Final Report - Corrections Required **Application No. LUPL-25-0008**

Document Filename : 241010_BLR Village C Land Use Plan.pdf

BANNING LEWIS RANCH - VILLAGE C

BANNING LEWIS RANCH - VILLAGE C
LAND USE PLAN
COLORADO SPRINGS, CO
COVER SHEET

*Dwelling, Single-family Detached; Dwelling, Single-family Attached; Dwelling, Two-family (duplex).

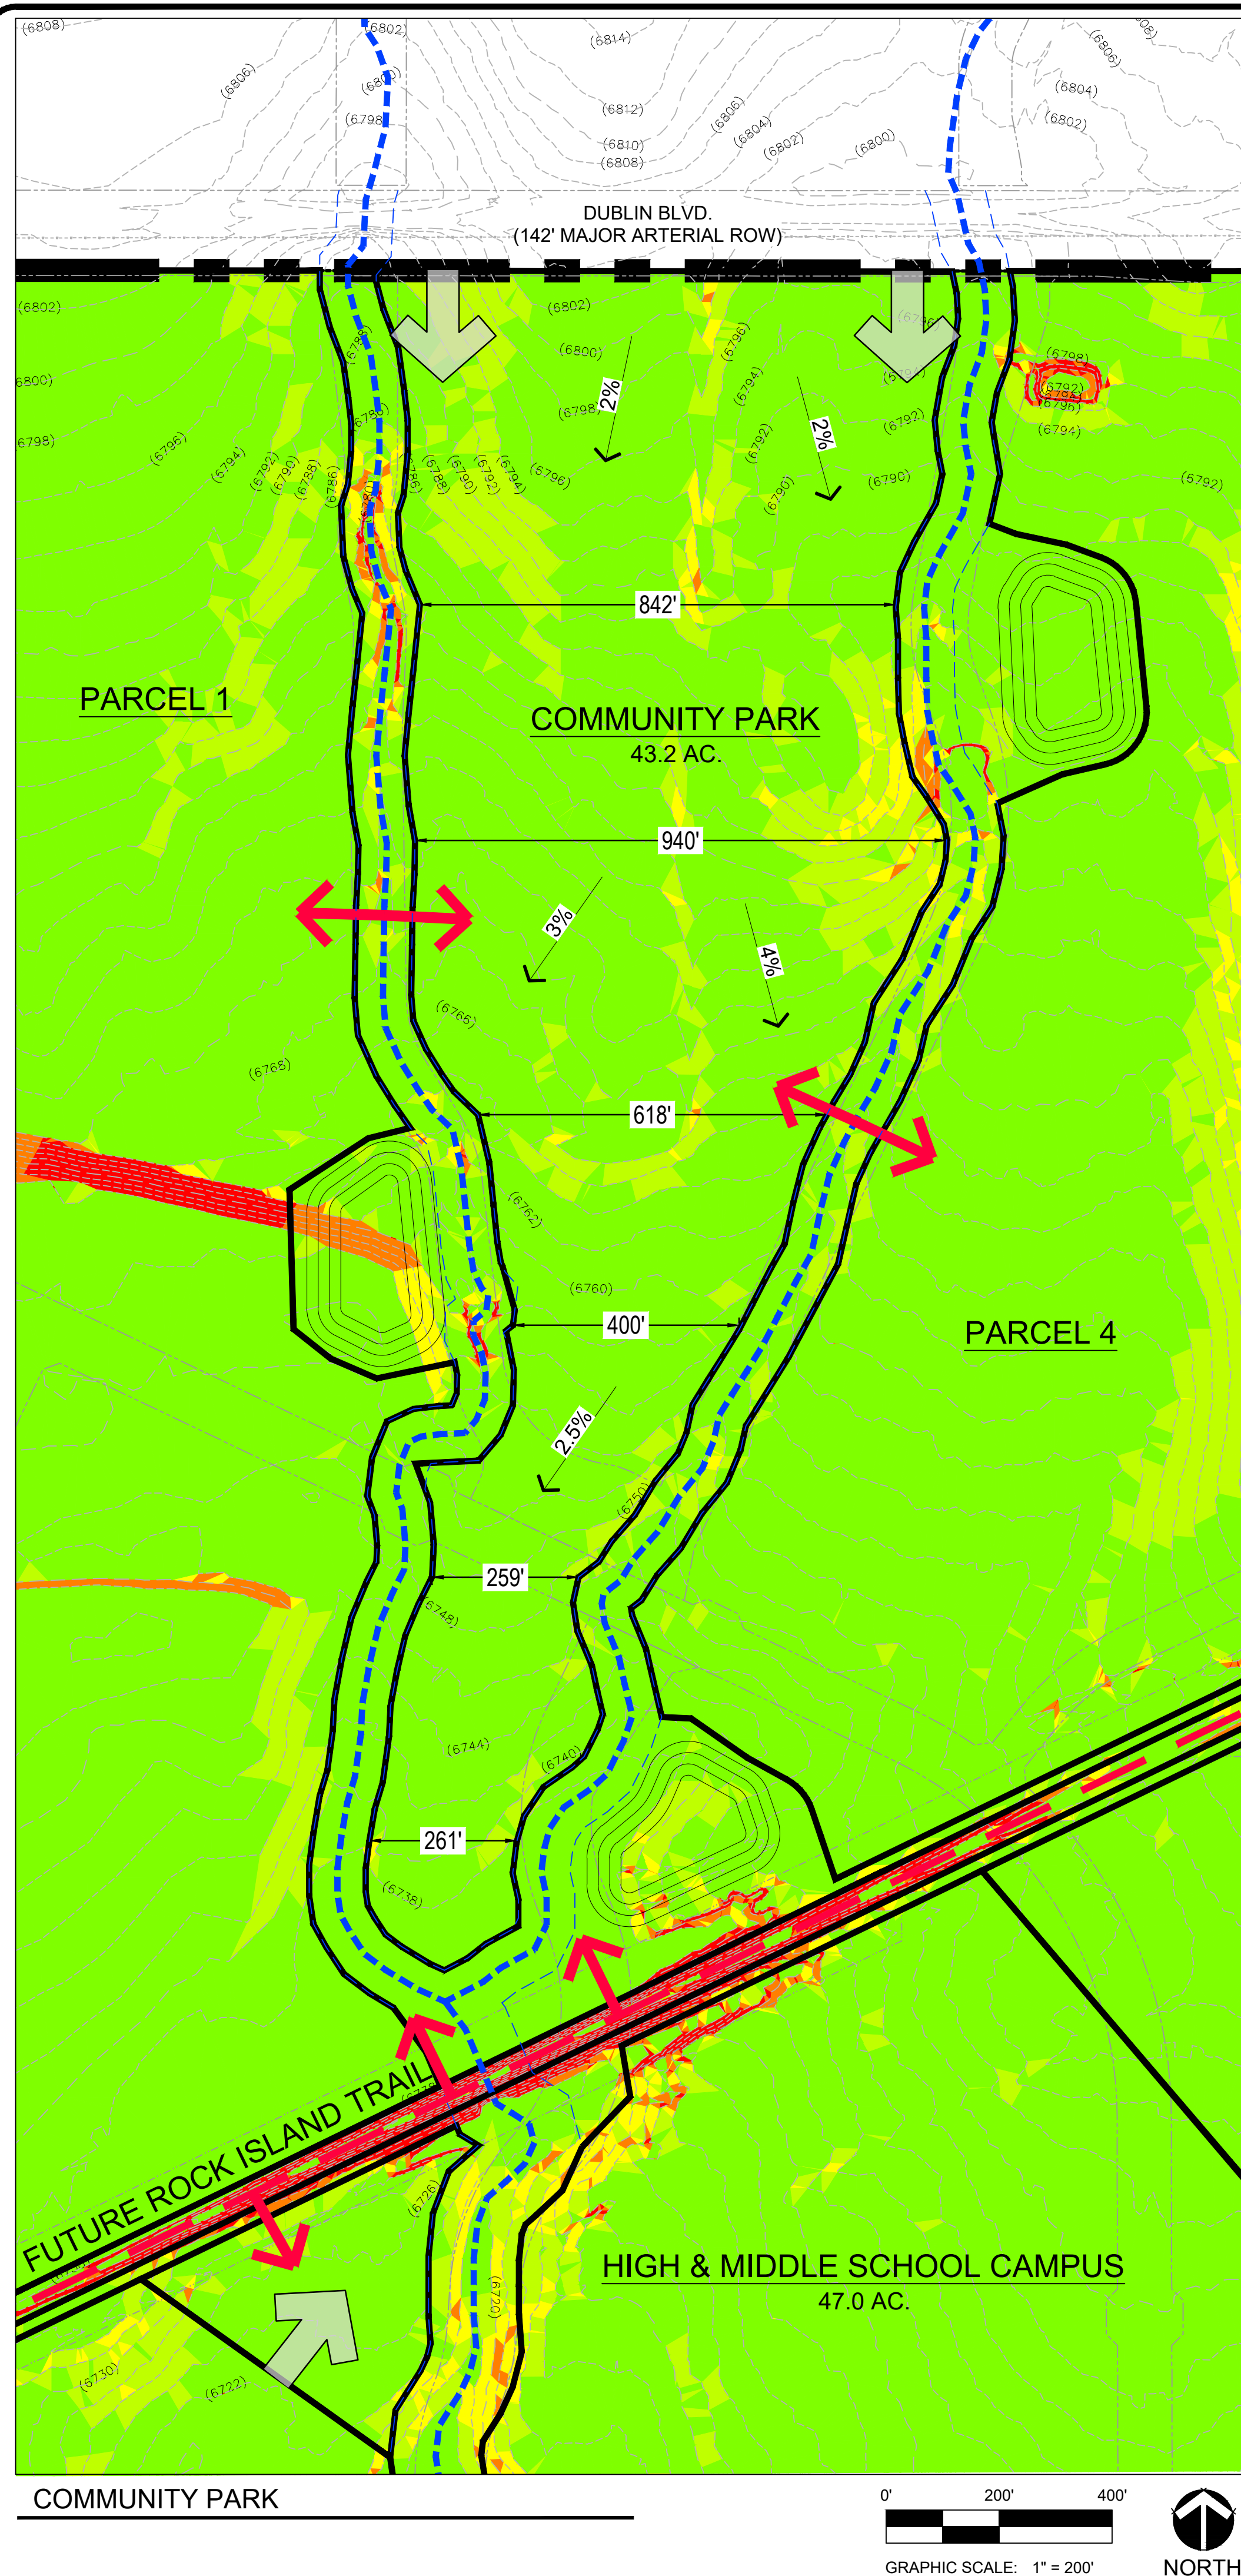
53	2	Tamara Baxter : Planning	Please use this on the coversheet as well.
54	2	Tamara Baxter : Planning	What does this residential encompass?
30	3	Caroline Miller : Planning	This graphic doesn't match the LUP Bubbles shown on page 2, park is not next to Public Safety.

BANNING LEWIS RANCH - VILLAGE C
LAND USE PLAN
COLORADO SPRINGS, CO
BLR MASTER PLAN

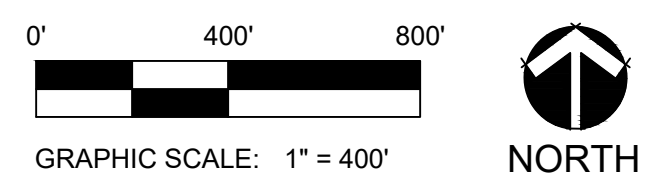
Refer to the date of this plan...ie what version.
